RAI Volume 3, Chapter 2.2.1.4.3, First Set, Number 1:

Figure 1. Locations of Particles Released from below the Repository and Tracked with FEHM's Streamline Particle Tracking Routine (SPTR) at the Accessible Environment Boundary

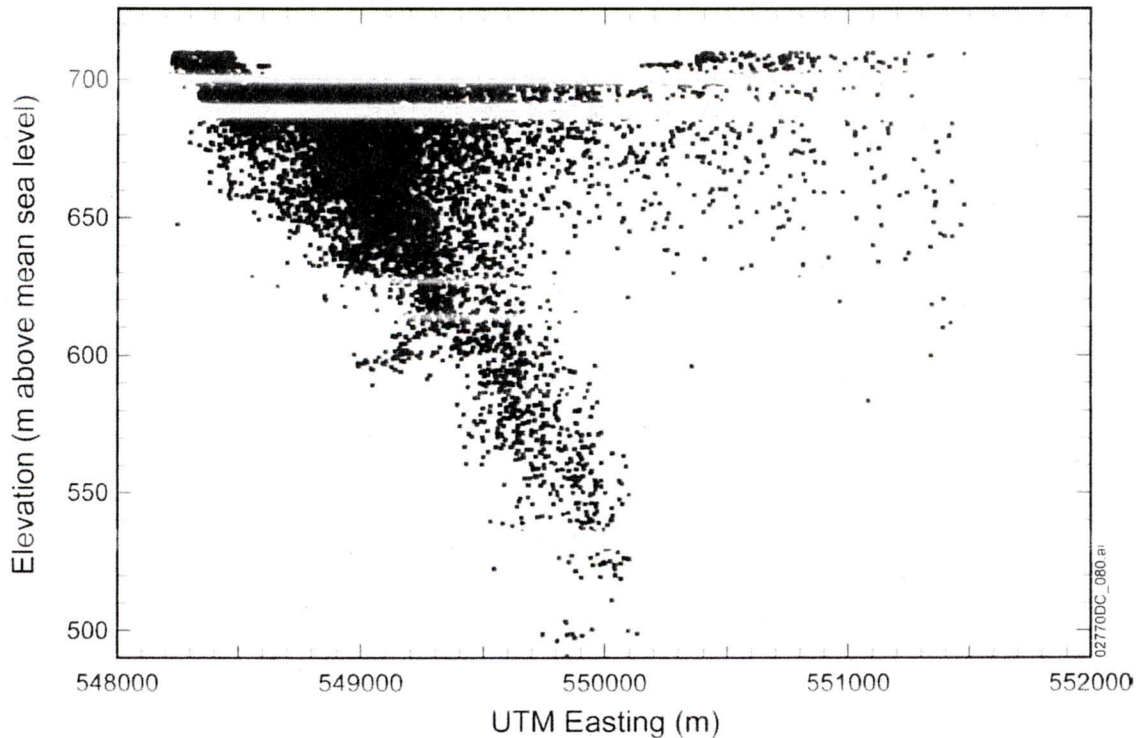
Provide further information that clarifies how the dimensions of the representative volume used to address ground water protection standards were determined. In particular, describe: (1) how the traces of the particle tracks were used to define the dimensions of the cross section perpendicular to the direction of ground water flow, (2) the basis for the distance used for the dimension in the direction of ground water flow, and (3) the effect that climate change, within the first 10,000 years, has on the dimensions of the representative volume.

Basis: The dimensions of the cross section of the representative volume perpendicular to the direction of ground water are defined by particle traces (Section 2.4.4.3.2). However, the license application provides limited discussion regarding the particle traces (e.g., relationship between the number of particle traces and the number of breached waste packages, how the traces were used to determine the dimensions of the cross section, relationship between the traces and concentration in the representative volume). The dimension of the representative volume in the direction of groundwater flow is calculated to be 30 meters, but, there is limited discussion of the basis for this value (e.g., bases for the values used in the calculation).

Figure 2.3.9-14 illustrates particle tracks from beneath the repository to the southern edge of the site-scale saturated zone flow model. Plan and vertical views of these particle tracks in the figure provide limited information related to the areal extent of the plume normal to the flow direction at the accessible environment boundary. The resulting shape of the plume intersecting the accessible environment boundary is described as a rectangle 3000 m long and 200 m deep. However, if the edges, i.e., sides and bottom, of the plume are irregular, a smaller areal extent could be calculated.

The use of a simple rectangle circumscribing the simulated plume to define the cross-sectional area of the plume will always overestimate the cross-sectional area if the plume shape fits within the perimeter of the rectangle. Figure 1 presents the locations of particle traces crossing the east-west oriented vertical plane defining the accessible environment boundary derived from the base-case site-scale saturated zone transport model (SNL 2008a). Unlike the simulation used to generate SAR Figure 2.3.9-14, which does not include the influence of dispersion (SNL 2007, Section 6.5.2.3), the simulation used to generate Figure 1 includes the effect of dispersion. The simulation uses an expected value for dispersivity of 100 m (SNL 2008a, Table 6-8). Inclusion of dispersion slightly increases the spread of the particle locations, in contrast to the non-dispersive case. Although the simulation depicted in SAR Figure 2.3.9-14 differs slightly from simulation used to generate Figure 1, for the purpose of examining the implications of the shape of the plume, Figure 1 is a useful surrogate.

As can be seen in Figure 1, the horizontal extent of the plume is approximately 3,300 m and the vertical extent of the plume is about 220 m. For this simulation, a rectangular cross section defined by the horizontal and vertical extent of the plume would be approximately 726,000 m². This figure also shows that based on the particle traces, roughly 40% of a rectangular cross section defined by the horizontal and vertical extent of the plume would be outside the plume as described by the particle traces. The estimate of 40% is based on the assumption that the plume is not found in an approximately 1,600 m × 160 m triangular area located in the bottom-western part of the rectangular cross section and in an approximately 1,400 m × 95 m rectangular area located in the bottom-eastern part of the rectangular cross section. This would mean that the plume is not found in 261,000 m² of a 726,000 m² rectangular cross section or in 40% of the rectangular cross section if the ratio is rounded to one significant figure. If the plume is irregular, a smaller areal extent could be calculated. Taking into consideration the irregularities in the plume depicted in the simulation results presented in Figure 1, a calculation of the plume cross-sectional area would produce a cross-sectional area of 435,000 m² (726,000 m² × 60%). Although a smaller plume area could be calculated, since the dimensions of the representative volume are not used in the TSPA model, a simple 600,000 m² rectangular approximation of the cross section of the plume is a reasonable and conservative approach to defining the representative volume.
